Docket No. 52-001

SUBJECT: FINAL REPORT TO DOCUMENT THE DISPOSITION OF THE IIRG COMMENTS
ON THE GE NUCLEAR ENERGY (GE) ADVANCED BOILING WATER REACTOR
(ABWR) INSPECTIONS, TESTS, ANALYSES, AND ACCEPTANCE CRITERIA
(ITAAC)

INDEPENDENT REVIEW GROUP COMMENTS REQUIRING DISPOSITION BY GE

Figure 2.2.10 Steam Bypass and Pressure Control System Control Interface Diagram

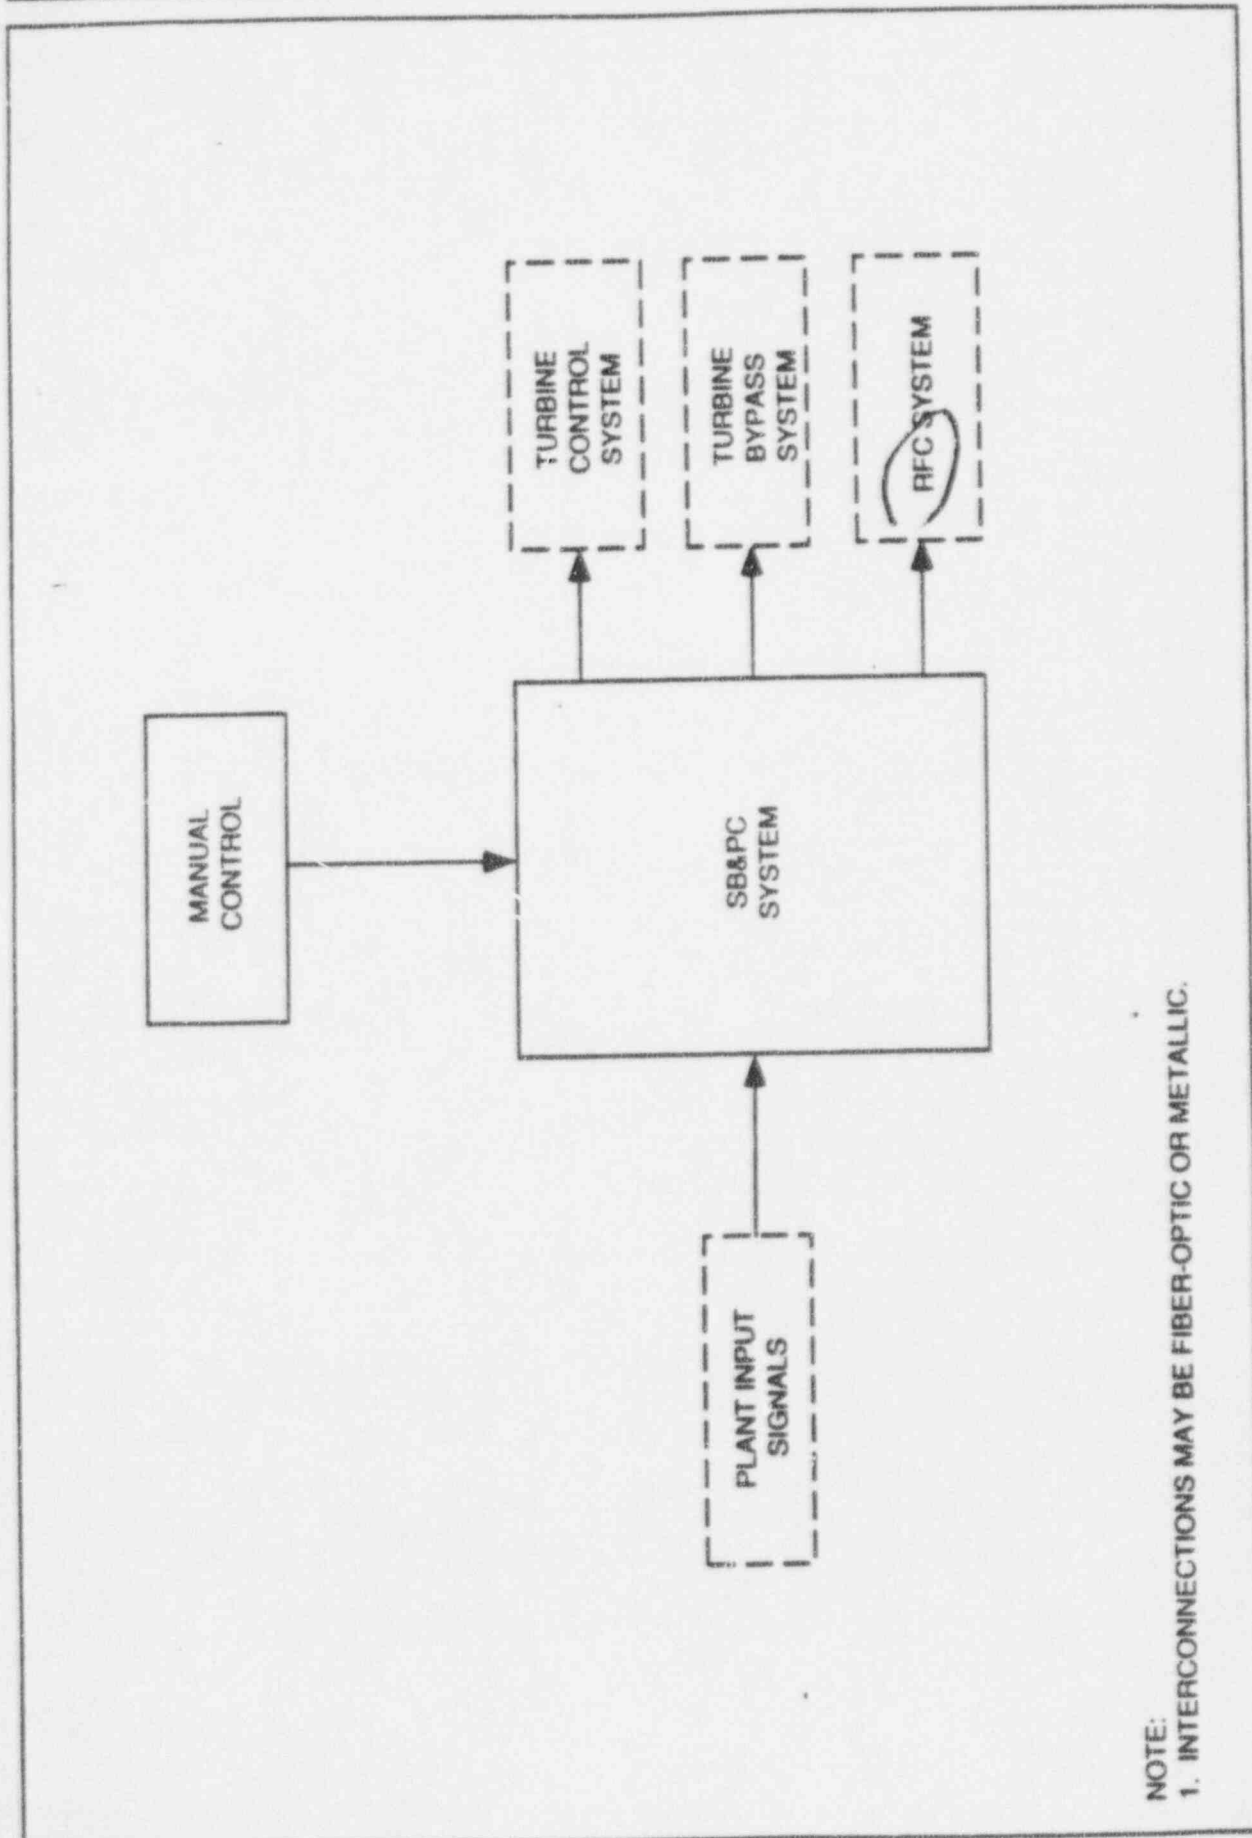
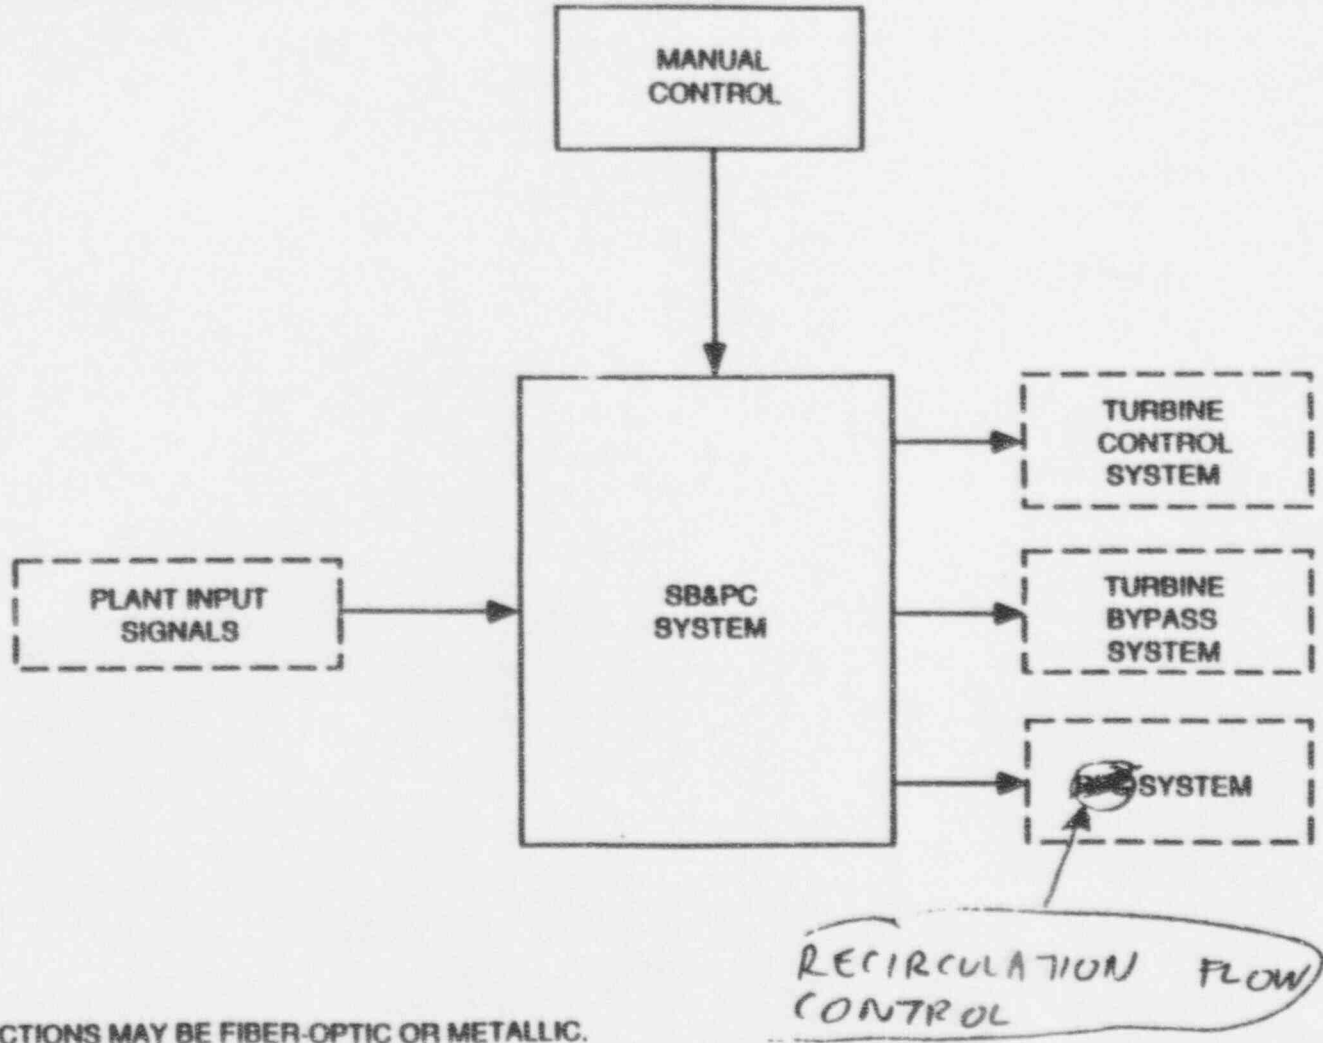
Figure 2.2.10 labelling of interfacing systems are listed as Turbine Control System, Turbine Bypass System and RFC system. The labelling is inconsistent.

GE does not believe there are any inconsistencies requiring CDM changes. The SB&PC does in fact provide pressure signals to the RFC System for ATWS logic as shown on SSAR Figure 15E-1 and CDM Figures 2.2.8 and 2.2.10. The APR/RFC interface shown on Figure 2.2.9 is associated with the APR control function and is input to RFC for reactor power regulation (via flow control).
